FIRE SAFETY INSPECTION REPORT

WELDONE APPAREL LTD
BARAIDRCHALAE, SREEPUR, GAZIPUR

ACCORD
on Fire and Building Safety in Bangladesh

June 1, 2014

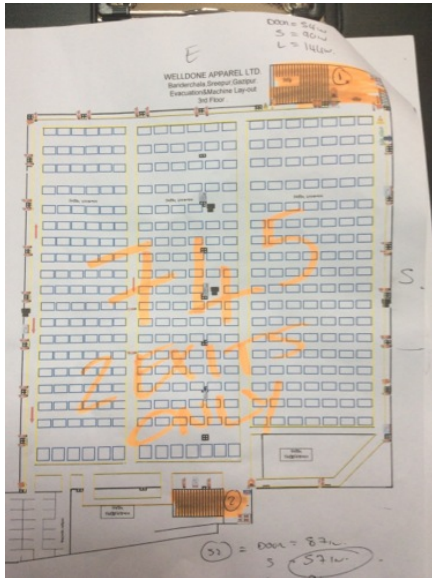
F-3	Fire Rated Construction	The exit stairs are not separated from work areas on each floor by fire-rated construction through out the factory building.	Provide minimum 1.5-hr fire rated doors and seal all unprotected openings to separate the exit stairs from work areas and other building spaces on all floor levels. Ensure that the fire doors are self-closing and positive latching and that they are provided with fire exit (panic) hardware where serving production floors.	Within 3 months
-----	-------------------------	--	--	-----------------

If fire doors are required to be held open for functional reasons, provide automatic-closing devices tied to the fire alarm system.
